**ENGINEERING REVIEW  
FOR REZONING 18.673**

TO: BARB MCBETH, PLANNING DIRECTOR  
FROM: BRIAN COBURN, P.E.; CIVIL ENGINEER *BC*  
SUBJECT: ENGINEERING REVIEW OF REZONING REQUEST 18.673  
DATE: DECEMBER 12, 2007

Basilian Residence and Conceptual/PRO

**Re: New Basilian Fathers Residence – Planned Rezoning Overlay Concept Plan – 2<sup>nd</sup> Review**  
SP No. 07-59  
OHM Job No. 163-07-0392

# Utility Location Map

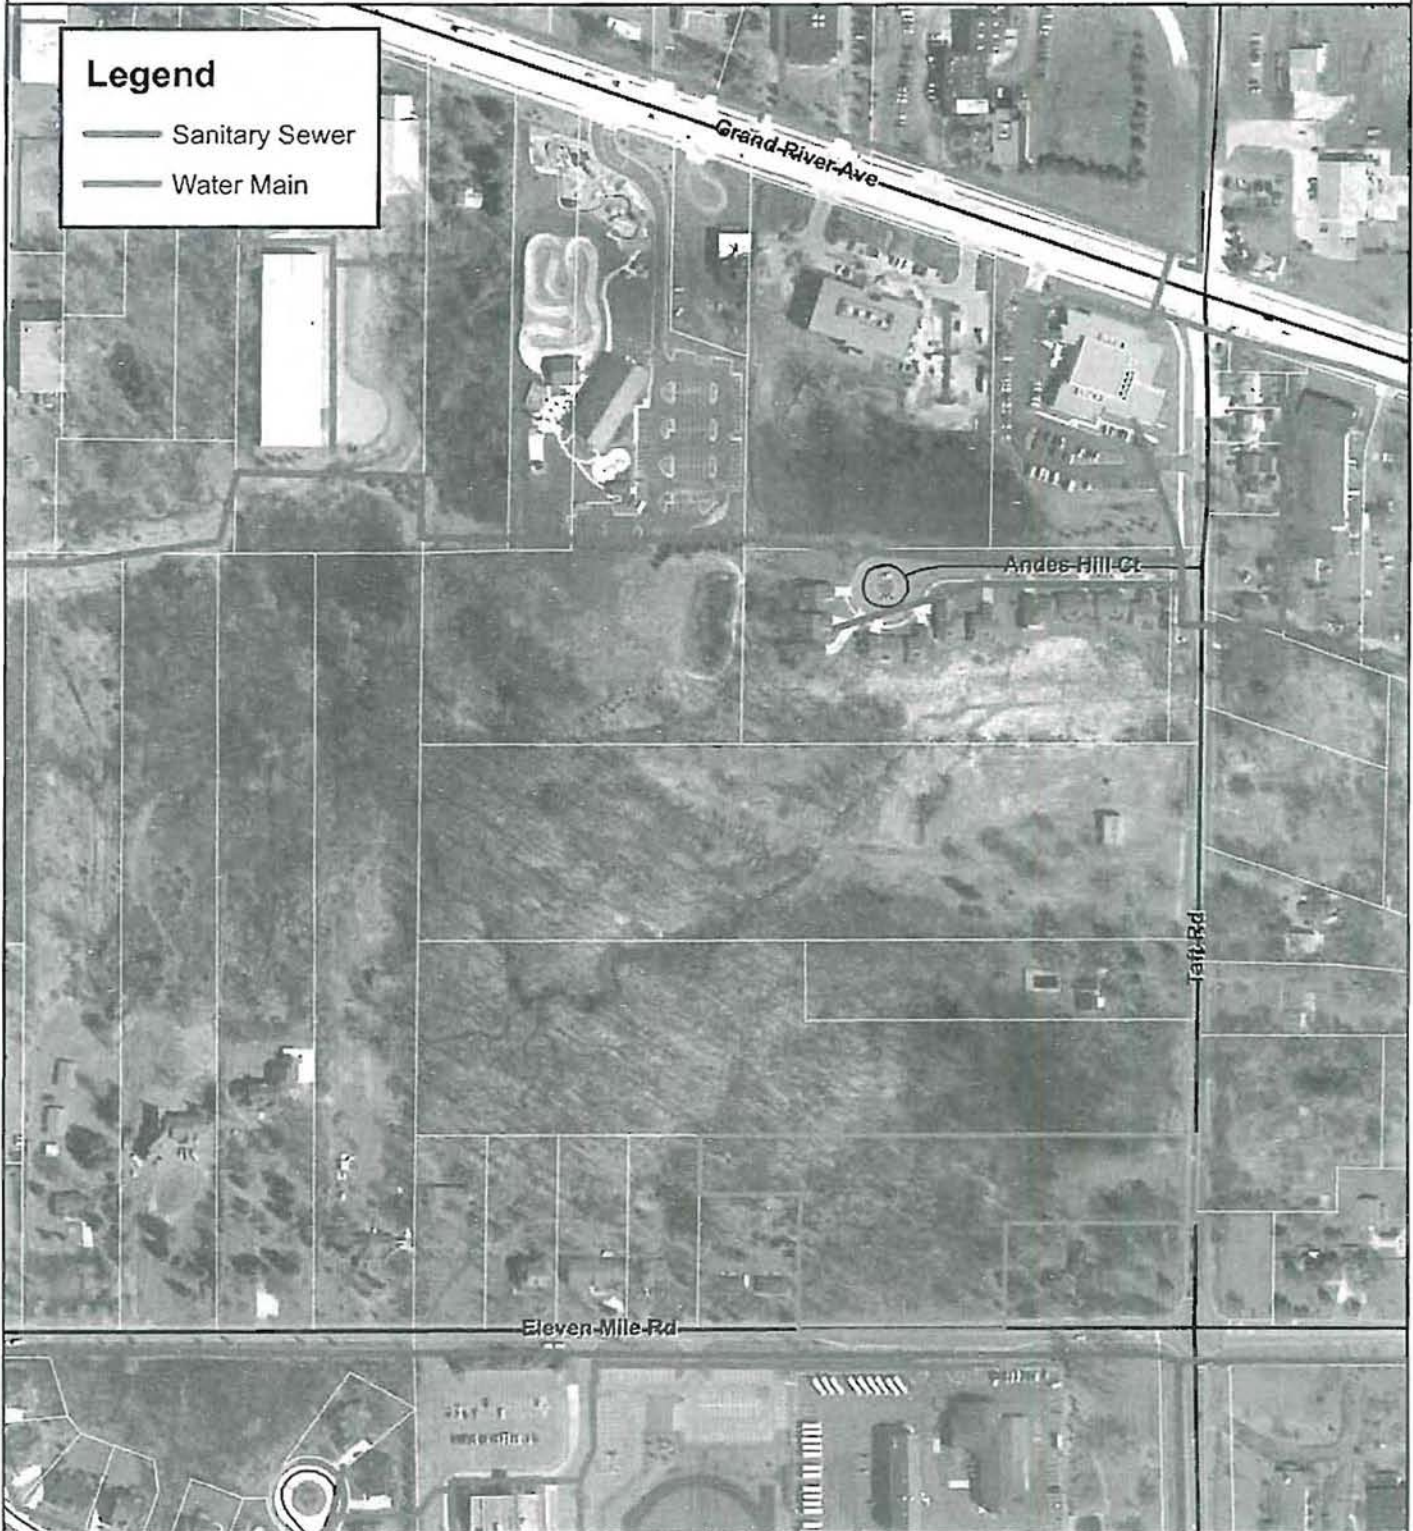
Water service is currently available from the existing water main located along Eleven Mile Road in front of the Novi Schools' Bus Garage. The water main should be extended along the Eleven Mile Road and Taft Road frontages to provide for future extension to improve the reliability of the system. The City's water model indicates that the development of the PRO concept plan would not have a negative impact on the overall system.

While there is a sanitary sewer located on the south side of Eleven Mile Road, this site is in a different sewer district and is unable to discharge to the Eleven Mile sewer. A sanitary sewer must be constructed along the Taft Road frontage and extended north along Taft connecting to the sanitary sewer that crosses Taft Road just south of Andes Hills Condominium. Based on the concept plan provided, there would be minimal, if any, impact on the capacity of the sanitary sewer system.
